# DEPARTURE REQUESTS

# DEPARTURE EXHIBITS

D3 --- Departure Request

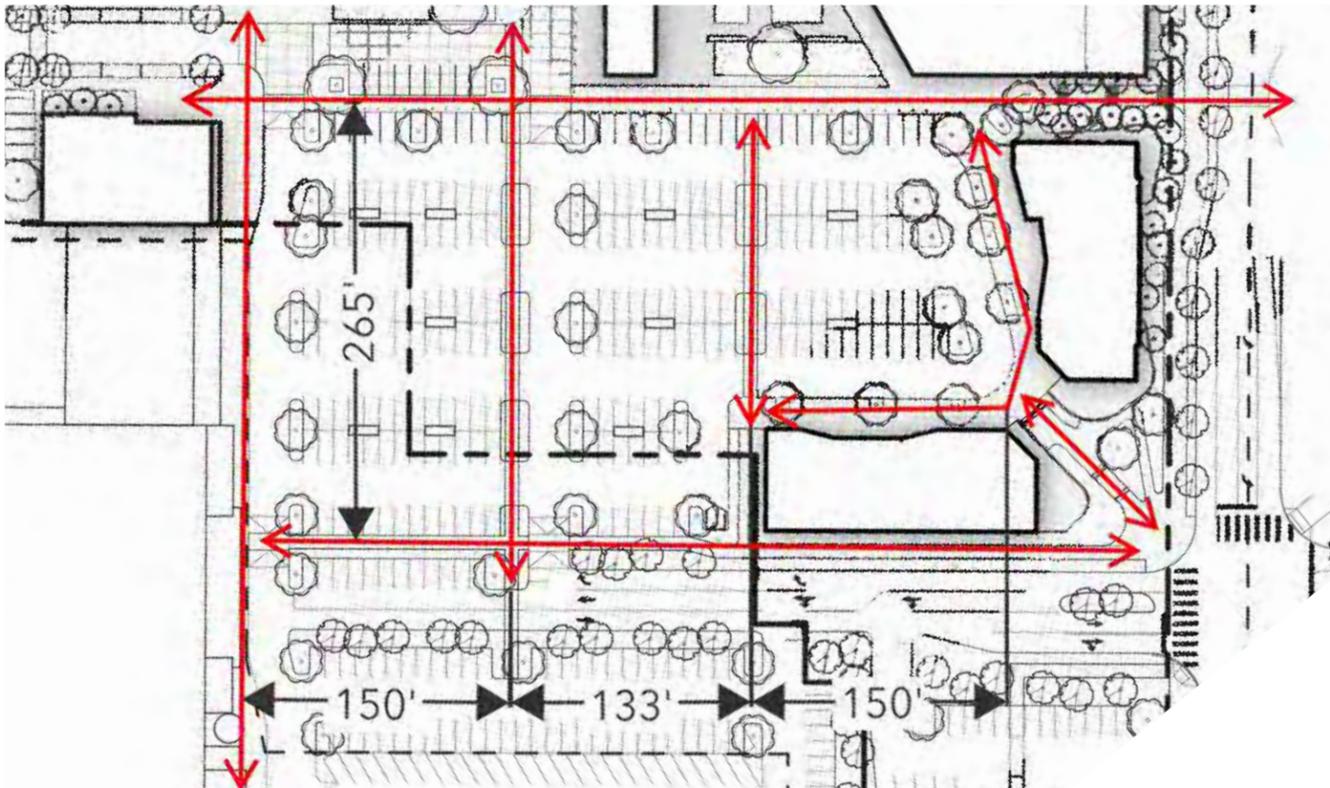
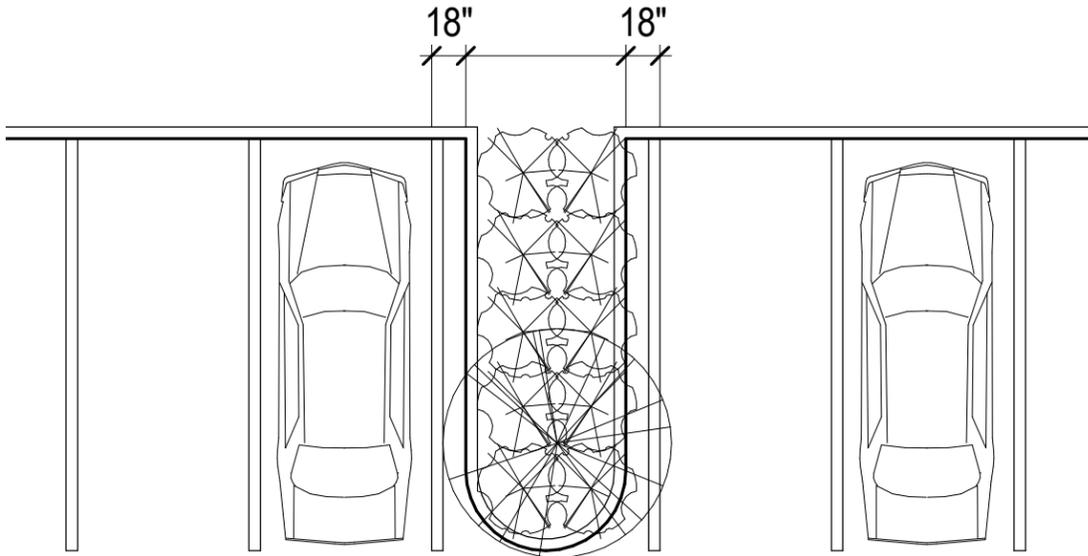
D2	20.50.240.E.1.a	Site Design - Internal Site Walkways	All development shall provide clear and illuminated pathways between the main building entrance and a public sidewalk. Pathways shall be separated from motor vehicles or raised six inches and be at least 8 feet wide	Allow for sidewalks along private residential streets and pathways not serving commercial uses to be reduced to 6 feet wide.	A 6' wide sidewalk along private residential streets with no commercial frontage would exceed the minimum 5feet wide sidewalk as required per. section 12.8 (Private Streets) of the Shoreline Engineering Manual.
D3	20.50.240.E.1.c	Site Design - Internal Site Walkways	Raised walkways at least eight feet wide shall be provided for every three, double-loaded aisles or every 200 feet of parking area width. Walkway crossings shall be raised a minimum three inches above drive surfaces	Allow for walkways to be provided for every 265 feet of parking lot width provided that no parking stalls is more than 100 feet from a walkway,	A parking lot with three code compliant double-loaded aisles exceed the minimum 200 feet aisle separation. The proposed site design creates a framework of well connected pedestrian scaled blocks that serves uses on multiple sides. The largest proposed distance between walkways is greater than 200 feet, however no stall is more than 100 feet from a walkway which is consistent with the intent of the code requirements.  <a href="#">Proposed Departure supported by Departure Exhibit D3</a>

D4 -- Departure Request

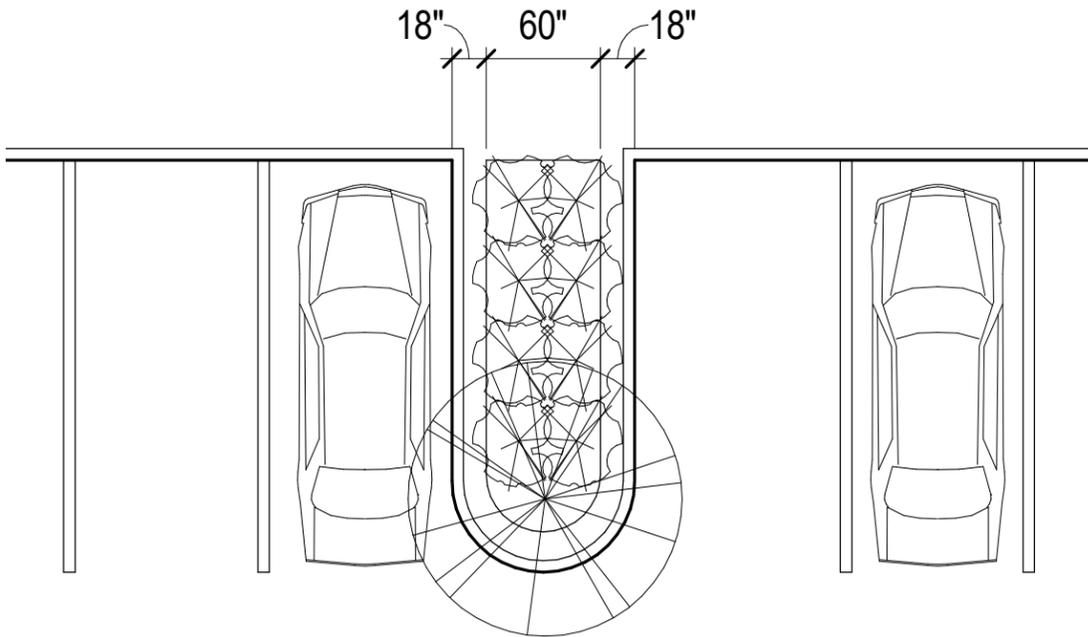
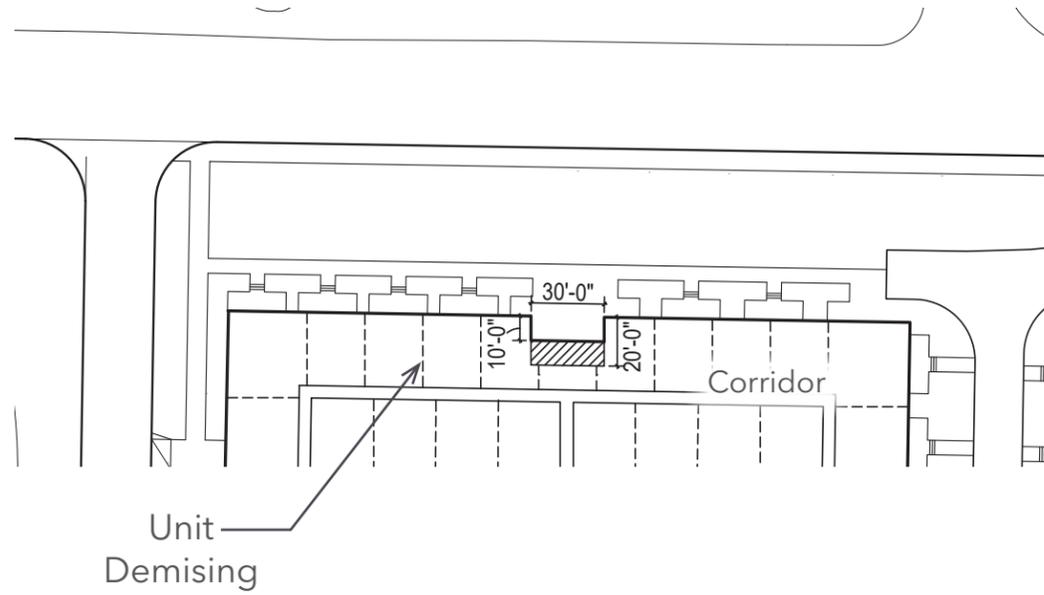
D4	20.50.410.H	Parking design standards	Parking spaces abutting a landscaped area on the shall provide an additional 18 inches to provide a place to step other than in the landscaped area. In a parking garage, any space abutting a wall shall provide an additional 18 inches.	Allow for the required 18" step-off to be provided with a 12" paving strip inside the 6" curb.	This departure would still achieve the goal of not requiring a driver or passenger to step into a landscape area, but onto a durable surface. This is the same condition that occurs at parallel street parking.  <a href="#">Proposed Departure supported by Departure Exhibit D4</a>
D5	20.50.410.F	Parking design standards	Stall size (width x length) to be: <ul style="list-style-type: none"> <li>Desired: 9' x 20'</li> <li>Minimum: 8.5' x 20'</li> <li>Compact: 8' x 16'</li> </ul> Note: up to 50% of stalls allowed to be compact stalls	Allow for the following stall sizes (width x length): <ul style="list-style-type: none"> <li>Desired: 9' x 18'</li> <li>Minimum: 8' x 16'</li> <li>Compact: 7.5' x 15'</li> </ul> Note: up to 50% of stalls allowed to be compact stalls	The site design recognizes that transient users require larger parking stalls due to the higher turn-over rate. With this in mind, the site plan includes a combination of 9'x 20' and 9' x 18' commercial stalls with a less than 25% of stalls being 9' x17'. Smaller stall sizes, specifically within residential buildings are more consistent with the urban character of the development and the goal of increasing land efficiency as outlined in the CRA.

D8 --- Departure Request --- Plan

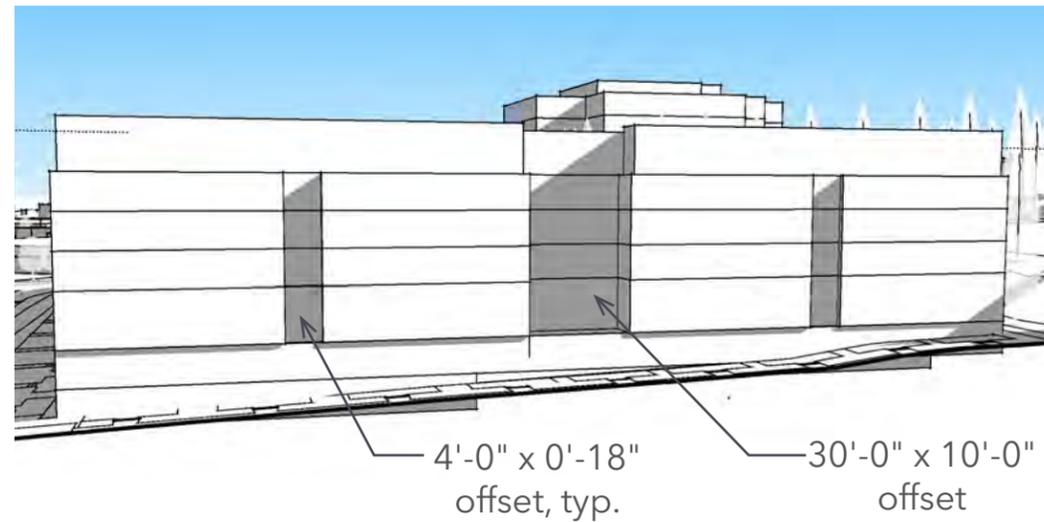
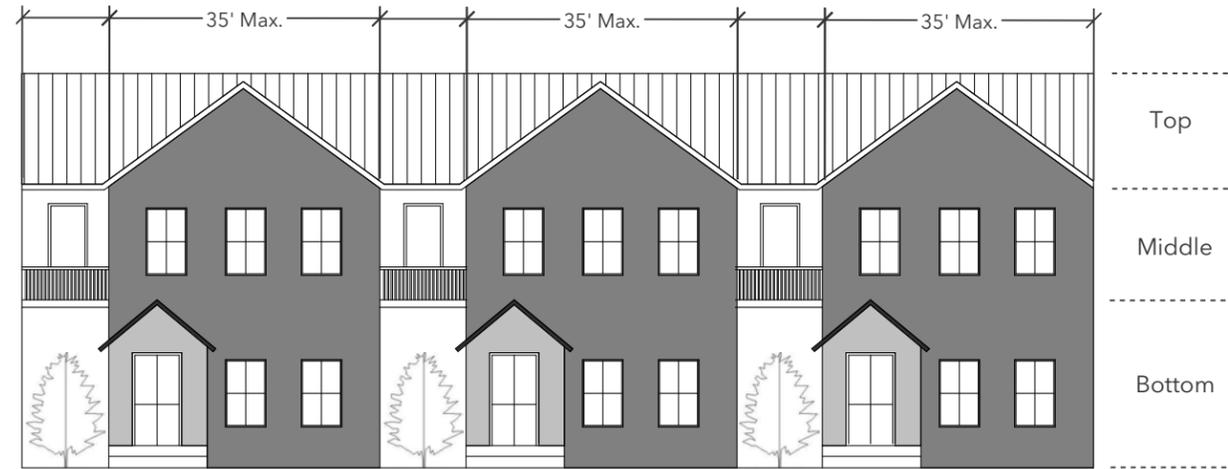
D8	20.50.250.B.5	Building Design - Building Articulation	<p>Every 150 feet in building length along the street front shall have a minimum 30-foot-wide section that is offset by at least 20 feet through all floors.</p>	<p>Every 150 feet in building length along the street front shall have a minimum 30-foot-wide section that is offset by at least 10 feet through all floors above the ground level floor.</p>	<p>Extending the required building articulation down to the ground level interrupts the consistency of the urban street frontage. A departure from this requirement would enhance the ground level experience as envisioned in the Aurora Square CRA.</p> <p><a href="#">Proposed Departure supported by Departure Exhibit D8</a></p>
